Access Compliance Report Public Rights-of-Way (Curb Ramps)

Main Street: MARBLE_ARCH_DR Cross Street: APPIAN_WAY Location: W

ADA ID: RPRK211012181443 Ramp Type: Type 4 - Parallel Initial Pass/Fail: Fail Overall Compliance: No Severity Score: 45

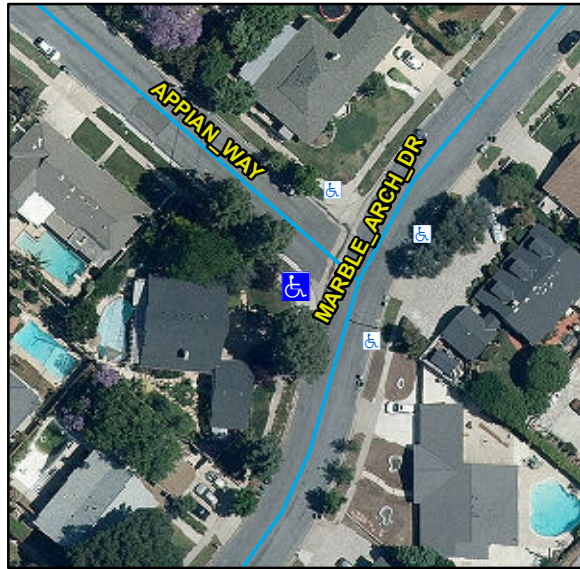
Compliance	Description	Data	Compliance	Description	Data
N/A	Ramp Length LT (in)	120	N/A	Ramp Length RT (in)	125
Yes	Ramp Width LT (in)	134	Yes	Ramp Width RT (in)	129
Yes	Ramp Run Slope LT (%)	2.6	No	Ramp Run Slope RT (%)	9.7
No	Ramp Cross Slope LT (%)	6.1	No	Ramp Cross Slope RT (%)	7.2
N/A	Landing Present	N/A	N/A	DWS Provided	N/A
N/A	Landing Length (in)	N/A	N/A	DWS Contrast	N/A
N/A	Landing Width (in)	N/A	N/A	DWS Length (in)	N/A
N/A	Landing Run Slope (%)	N/A	N/A	DWS Full Width	N/A
N/A	Landing Cross Slope (%)	N/A		DWS Offset Type	N/A
N/A	Landing Movement Obstructed?	N/A	N/A	DWS Offset Left (in)	N/A
	Landing Movement Type	N/A	N/A	DWS Offset Right (in)	N/A
N/A	Landing Shared	N/A			
N/A	Clear Space	Yes			
N/A	Clear Space To Crosswalk (in)	N/A			
N/A	Marked Crosswalk 1	No	N/A	Marked Crosswalk 2	No
	Crossing 1 Direction	SE		Crossing 2 Direction	NE
	Marked Crosswalk 1 Width (in)	N/A		Marked Crosswalk 2 Width (in)	N/A

Remove & Replace Curb Ramp With Two New Directional Ramps or Equivalent.
